| Office Action Summary | Application No. 10/581,415 | Applicant(s) MAIER ET AL. | |

DETAILED ACTION

This office action is responsive to the amendment filed on 7/06/09. As directed by the amendment: claims 10, 13-15, 18, 21, and 28 have been amended, claims 1-9 have been cancelled, and no new claims have been added. Thus, claims 10-29 are presently pending in this application.

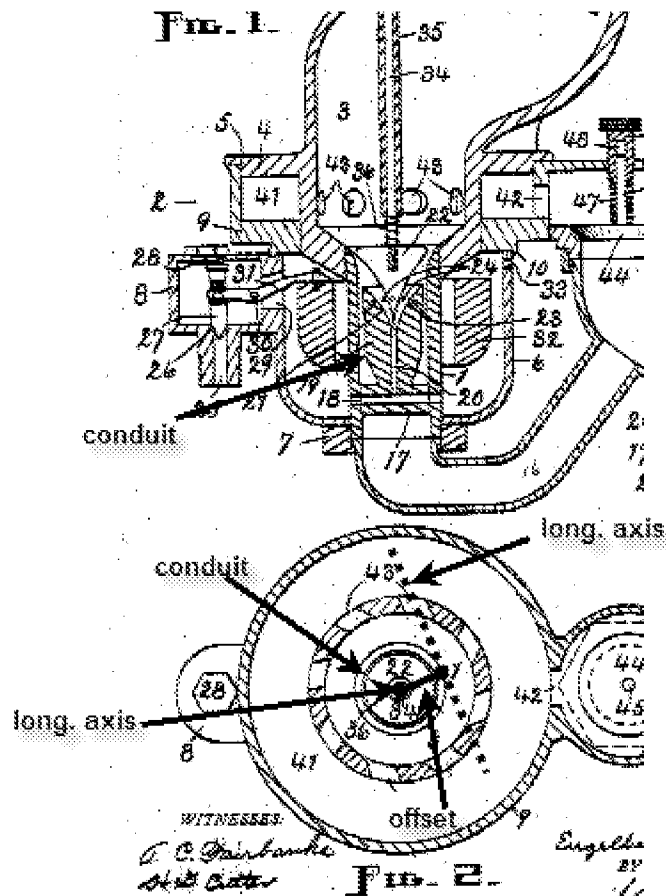
Regarding claims 10-27, as best understood, Burkhardt teaches an inlet valve assembly including a valve element 28 (fig. 2) disposed in a valve chamber 20 (fig. 1) and a fluid conduit 23/24 adjoining the valve chamber 20 on the upstream side, the valve element 28 alternatively opening and closing the fluid conduit 23/24 on the upstream side of the valve chamber 20, the fluid conduit has a substantially constant width (the width of each individual conduit is constant); wherein the fluid conduit 23/24 comprises a first conduit portion 23 and a second conduit portion 24 adjoining the first conduit portion 23, the longitudinal axes of the first and second conduit portions being at an angle less than 180° to one another; longitudinal axes of the first and second conduit portions are at least approximately at a right angle to one another; a ball as the valve element 26; wherein the first and second conduit portion 23/24, in cross section, have at least approximately the same radius; the first conduit portion 23 extends no more than an axially insignificant distance past the second conduit portion 24.

Hanemann teaches, as best understood, the fluid conduit (includes unreference conduit and conduit 43; see fig. 1 below) a has a substantially constant width and is embodied such that a rotation about the longitudinal axis of the fluid conduit is impressed on the fluid stream that flows toward the valve chamber, without a constriction of this fluid stream being produced; and the longitudinal axis of the first conduit portion 43 being laterally offset from the longitudinal axis of the second conduit portion (fig. 2 below); the lateral offset of the longitudinal axes is greater than the radius (the offset of the two axes is greater than the radius of conduit portion 43; also see fig. 2 below); further including a transition region 3 (chamber) between the first conduit portion 43 and the second conduit portion; wherein the transition region includes a wall (chamber wall) that is curved from the first conduit portion to the second conduit portion 43 [Note: the patentability of a product does not depend on its method of production, i.e. electrochemical removal. If the product in the product-by process claim is the same as or obvious from a product of the prior art, the claim is unpatentable even though the prior product was made by a different process. In re Thorpe, 777 F.2d 695, 698, 227 USPQ 964, 966 (Fed. Cir. 1985)], to provide a tangential discharge, equally and uniformly over the valve seat, preventing localized erosion or wear of the valve, and preventing shock and deflections that tend to interfere with the valve seating and sealing functions.

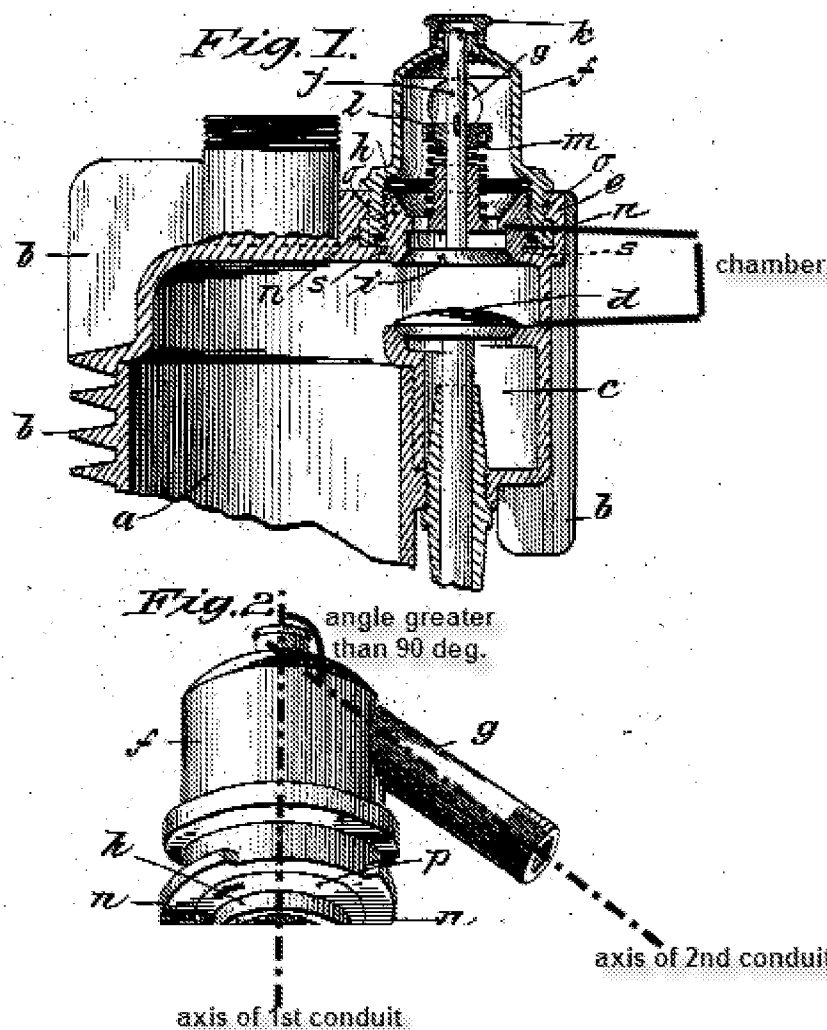
Regarding claims 10, 11, and 29, as best understood, Hedstrom teaches an inlet valve assembly including a valve element (i; fig. 1) disposed in a valve chamber 20 (see fig. 1 below) and a fluid conduit (g/f) adjoining the valve chamber on the upstream side, the valve element (i) alternatively opening and closing the fluid conduit (g/f) on the upstream side of the valve chamber, the fluid conduit (g/f) has a substantially constant width (the width of each individual conduit is constant); wherein the fluid conduit (g/f) comprises a first conduit portion (g) and a second conduit portion (f) adjoining the first conduit portion (g), the longitudinal axes of the first and second conduit portions being at an angle less than 180° to one another (fig. 2); the longitudinal axis of the first conduit portion (g) and the longitudinal axis of the second conduit portion (f) form an angle greater than 90° (see portion of fig. 2 below).

Hanemann teaches, as best understood, the fluid conduit (see fig. 1 above) a has a substantially constant width and is embodied such that a rotation about the longitudinal axis of the fluid conduit is impressed on the fluid stream that flows toward

the valve chamber (see fig. 2 above), without a constriction of this fluid stream being produced; and the longitudinal axis of the first conduit portion 43 being laterally offset from the longitudinal axis of the second conduit portion (fig. 2); the lateral offset of the longitudinal axes is greater than the radius (the offset of the two axes is greater than the radius of conduit portion 43; also see fig. 2 above).
